**Addendum No. 1**  
**Powell's Valley Water District**  
**New Office Building Project**  
**Bid Date: March 26, 2026**  
**Addendum Issue Date: March 23, 2026**

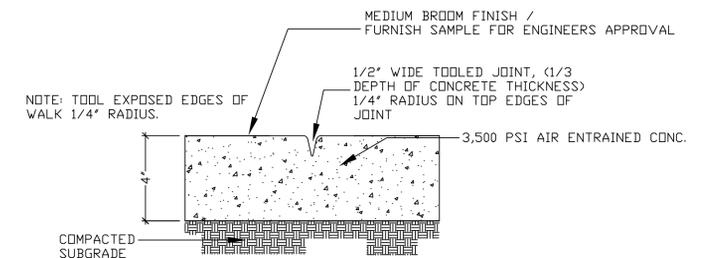
11. Is there a profile for the HMA parking/drive?  
Answer- Refer to new sheet C-2.
12. Will there be a Site Visit to review the existing conditions- Can site be visited anytime?

14. Please clarify scope - site concrete, grading. The Drawing provided shows finish elevations for grading, but I don't see details on the sidewalks, and don't see anything about the drive lanes. Concrete or asphalt?

Answer- Four (4) grommets, one per each wall-mount electrical outlet. Outlets are to be located above countertop.
10. Additional bollard information.  
Answer- Provide one bollard of Schedule 40 steel pipe (6" diameter), concrete fill, embed 2 feet or top of footing below grade, extend 3 feet above ground, paint for visibility

Answer- Please refer to new sheet C-2.
15. Please confirm the bid time and submission location. The specs provide two different places and times for proposals to be turned in.
